ZÁVAZNÝ SERVISNÍ BULETIN / MANDATORY SERVICE BULLETIN

TÝKÁ SE / CLARIFICATIONS: Damage to the flap drive torque tube in the fuselage.

OVLIVNĚNÉ VÝROBKY / AFFECTED PRODUCTS: TL 3000 Sirius serial numbers

ČÍSLO BULETINU / NOTICE ID: 3.S.SI.2017

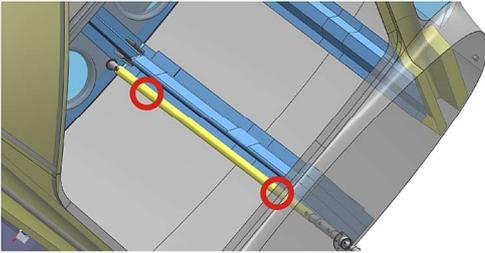
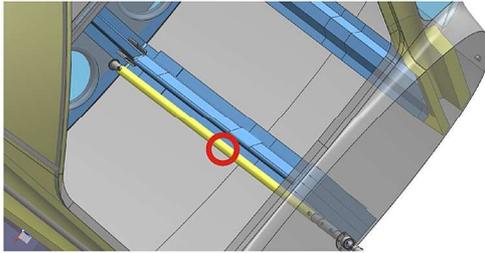
Sequence of steps	Description of Operation
1	<p>Aircraft preparation</p> <ul style="list-style-type: none"> - Move the plane into a suitable work area and fix wheel chocks - Make sure that all switches are off and the rescue system is secured against activation.
2	<p>Dismantling of overhead instrument panel</p> <ul style="list-style-type: none"> - Remove the overhead instrument panel from the ceiling panel (if the aircraft has an overhead instrument panel). The instrument panel is secured to the composite roof panel with seven M4x12 screws (cross headed). The instrument panel will remain suspended from the ceiling of the aircraft on the cables from the instruments. 
3	<p>Dismantling fuel gauge panel</p> <ul style="list-style-type: none"> - Remove both fuel gauges mounted on the sides of the composite ceiling panel. The sheets are fastened to the ceiling panel using four M4x12 screws (countersunk head with cross-slot).

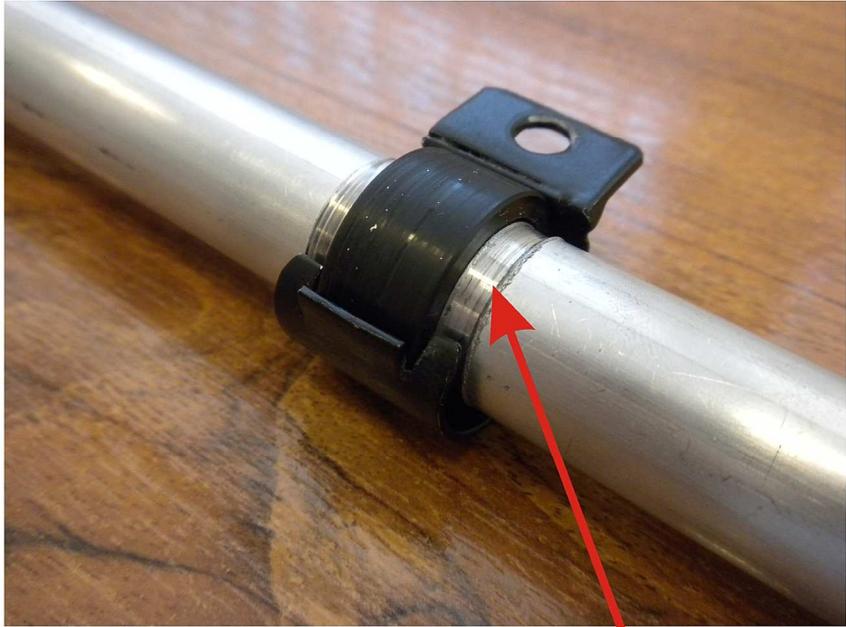
Sequence of steps	Description of Operation
<p style="font-size: 2em; font-weight: bold;">4</p>	<p style="font-weight: bold;">Dismantling the composite ceiling panel</p> <p>- Remove the composite ceiling panel. The panel is attached to the aircraft with M4x12 bolts and Velcro strips.</p> <div style="text-align: center;"> <p>Slotted mushroom head screws M4 x 12 (905624)</p>  </div> <div style="text-align: center;">  </div> <p>- After removal of the ceiling panel, the flap drive torque tube is open for inspection</p>
